SEWAGE DISPOSAL SYSTEM

MARYLAND STATE DEPARTMENT OF HEALTH

A SEWAGE DISPOSAL SYSTEM LOCATED AT 11865 Line Kelp Rd. - across road from
Buddy's store - 2000 ft. from Rt 216 on left

PROPERTY OWNER William Reed

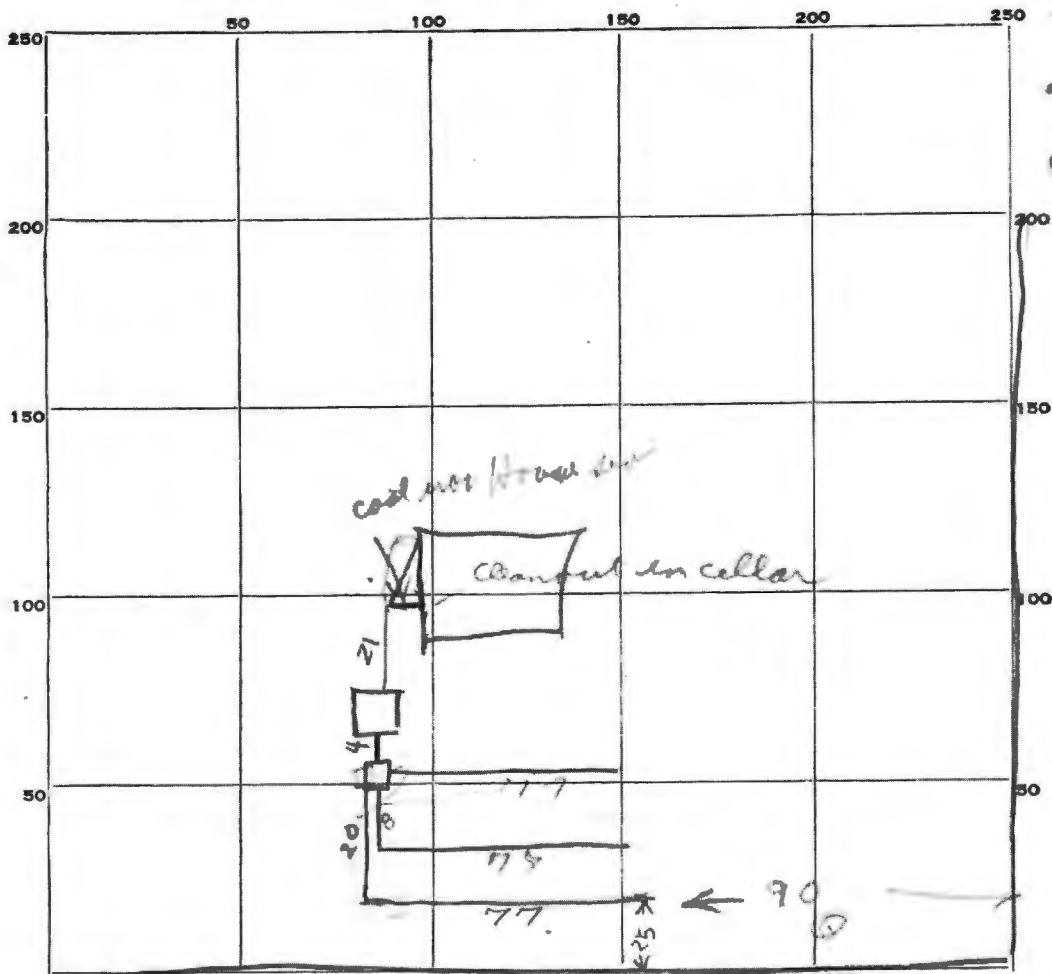
Place the tile field about 160 to 180 ft. from the side line of the lot, or the east of Rt 216 and 25 to 55 ft. from Line Kelp Rd.

28 May 63 3 bedrooms - 3 x 154 = 462 sq ft required
OK to cover tile field but septic tank must be re-inspected
for cleanout. Would tree (3) house sewer R/W

P 33832
 REED
 11865 LIMEKILL RD

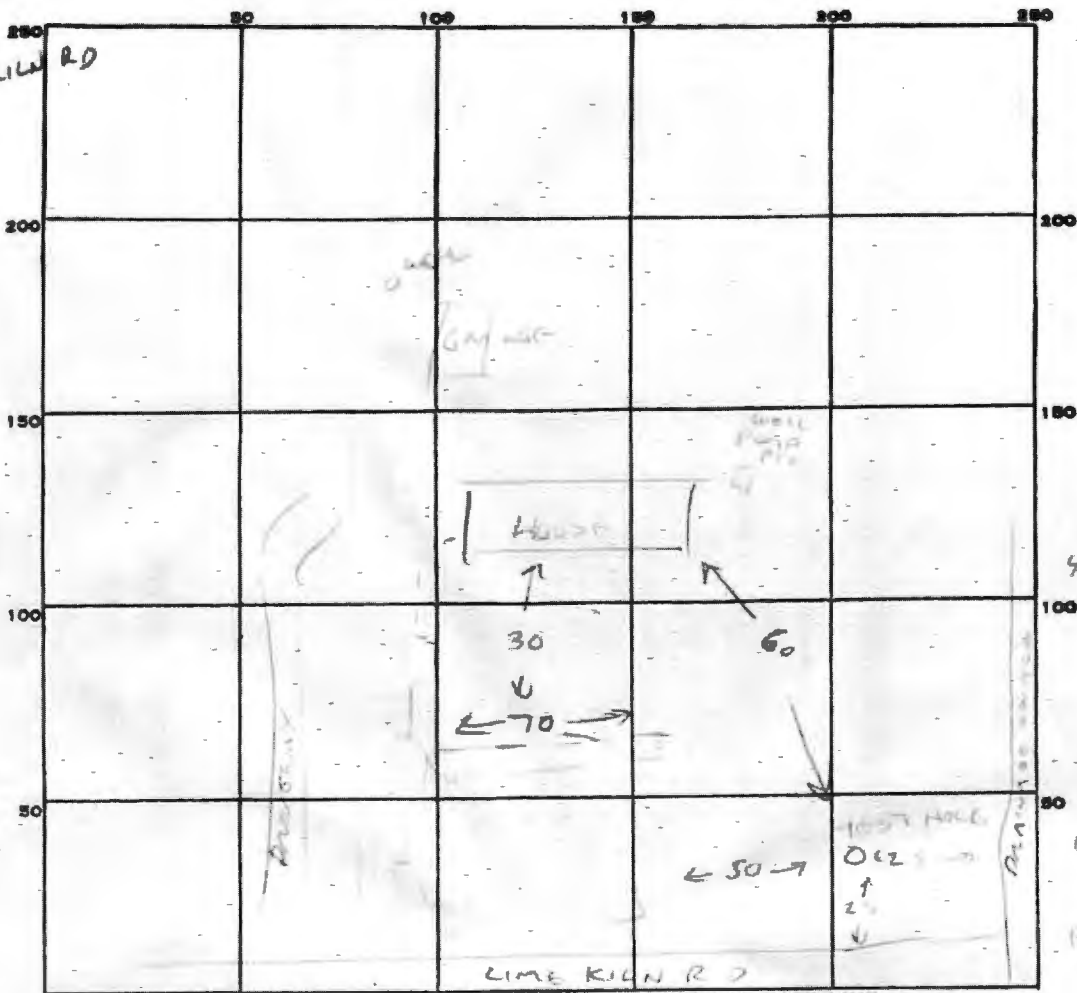
REMARKS 9/23/87 TEST HOLE WGT AT 6', CLAY TO 5' - FAILED.

NO ROOM TO INCREASE SEPTIC AREA ANY WHERE ON PROPERTY.

SYSTEM IS FUNCTIONING OK AT THIS TIME.

ADEQUATE A/C REMAINS FOR 2 REPAIR SYSTEMS.

1 BR. CONVERSION OK - ADDITIONAL BEDROOMS CAN BE ACCOMMODATED.

*SYSTEM LATER REPAIRED (5/11/89) - SAME PERMIT, SEE ATTACHED. C. Williams
